Title - Sujet Health Care Expansion	
Solicitation No. - N° de l'invitation EZ899-181607/A	Amendment No. - N° modif. 004
Client Reference No. - N° de référence du client	Date 2017-12-06
GETS Reference No. - N° de référence de SEAG PW-\$PWY-025-8228	
File No. - N° de dossier PWY-7-40258 (025)	CCC No./N° CCC - FMS No./N° VME
Solicitation Closes - L'invitation prend fin at - à 02:00 PM on - le 2017-12-20	Time Zone Fuseau horaire Pacific Standard Time PST
F.O.B. - F.A.B. Plant-Usine: <input type="checkbox"/> Destination: <input checked="" type="checkbox"/> Other-Autre: <input type="checkbox"/>	
Address Enquiries to: - Adresser toutes questions à: Fung, Donna(PWY)	Buyer Id - Id de l'acheteur pwy025
Telephone No. - N° de téléphone (604) 671-9689 ()	FAX No. - N° de FAX (604) 775-6633
Destination - of Goods, Services, and Construction: Destination - des biens, services et construction: CSC - Mountain Institution - Agassiz, BC

This Amendment No. 004 is raised to incorporate Addendum #01.

ADDENDUM #1

PROJECT: Mountain Institution Health
Care Expansion

Drawing title/thème du dessin
FOUNDATION
AND CRAWL SPACE
PLAN

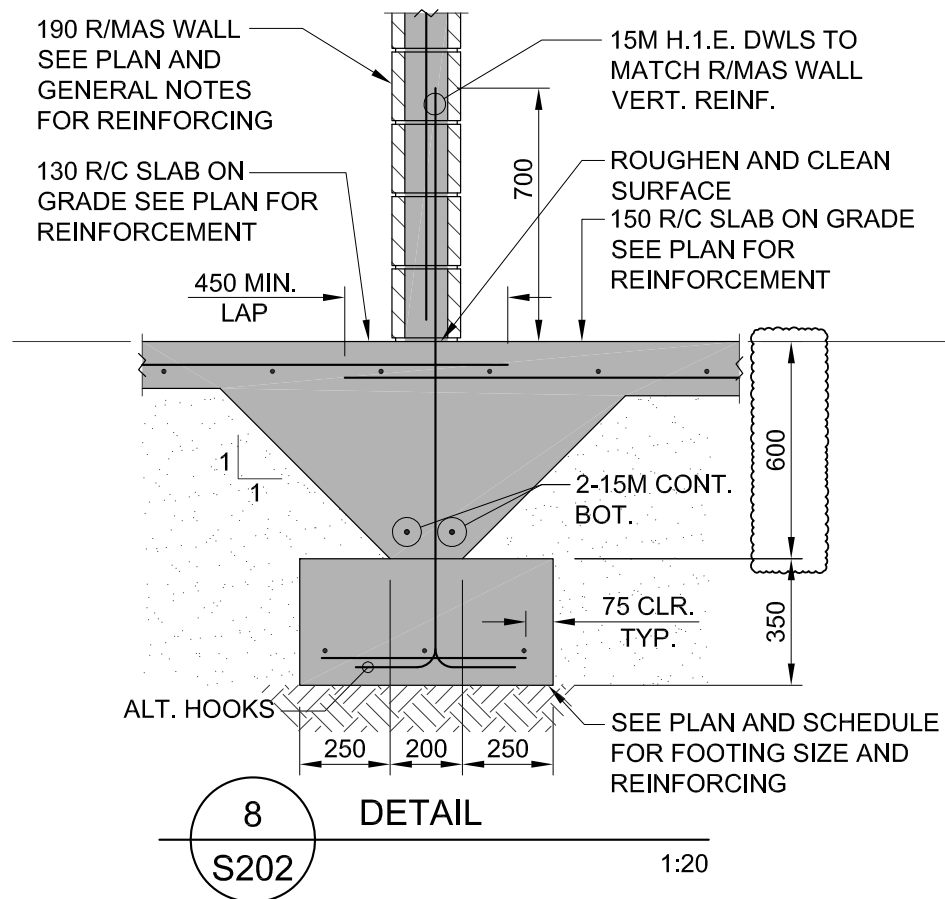
- .3 Reference: **DRAWINGS** Drawing S201 FOUNDATION AND CRAWL SPACE PLAN
- a) **[REVISE]** drawing per Structural Addendum #1 Drawing S201
- .4 Reference: **DRAWINGS** Drawing S202 MAIN FLOOR PLAN

1. Refer to drawing S201:
 - a. Added top of footing elevations.
 - b. Added additional steps where required.
 - c. Added detail 14/S310.
2. Refer to SSK-01:
 - a. Revised detail call-out.
3. Refer to SSK-02, SSK-03, SSK-04, SSK-06:
 - a. Revised footing depth.
4. Refer to SSK-05:
 - a. Revised block-out depth for HSS column.
5. Refer to SSK-06:
 - a. New strip footing detail.

- Answer: Refer to the Structural Addendum #1 S201 for top of footing elevations. Top of elevation of walls are typically to the main floor elevation, refer to relevant details for top of wall elevations.

Answer: Yes there is a step at this location, refer to the Structural Addendum #1 S201.

SSK-02

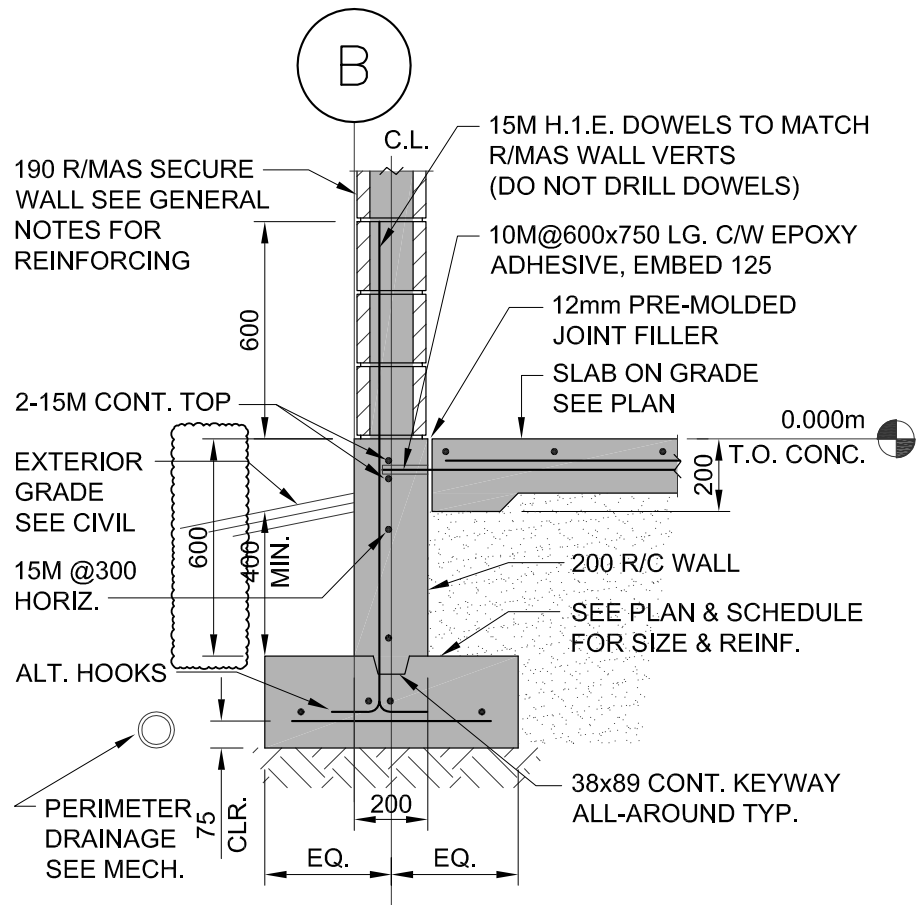
- a) **[REVISE]** drawing per Structural Addendum #1 Sketch SSK-01
- .5 Reference: **DRAWINGS** Drawing S300 SECTIONS AND DETAILS SHEET 1
- a) **[REVISE]** detail 8/S202 per Structural Addendum #1 Sketch SSK-02

FOOTING DEPTH CLARIFIED

SSK-03

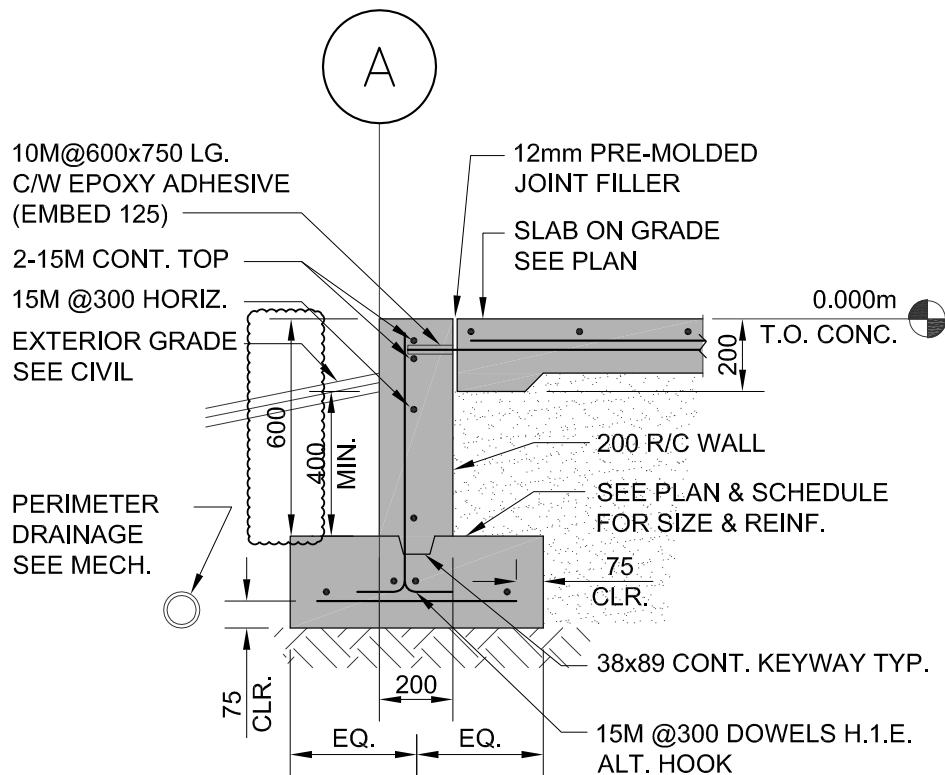
- .6 Reference: **DRAWINGS** Drawing S310 SECTIONS AND DETAILS SHEET 3
- a) **[REVISE]** detail 5/S202 per Structural Addendum #1 Sketch SSK-03
 - b) **[REVISE]** detail 6/S202 per Structural Addendum #1 Sketch SSK-04

FOOTING DEPTH CLARIFIED
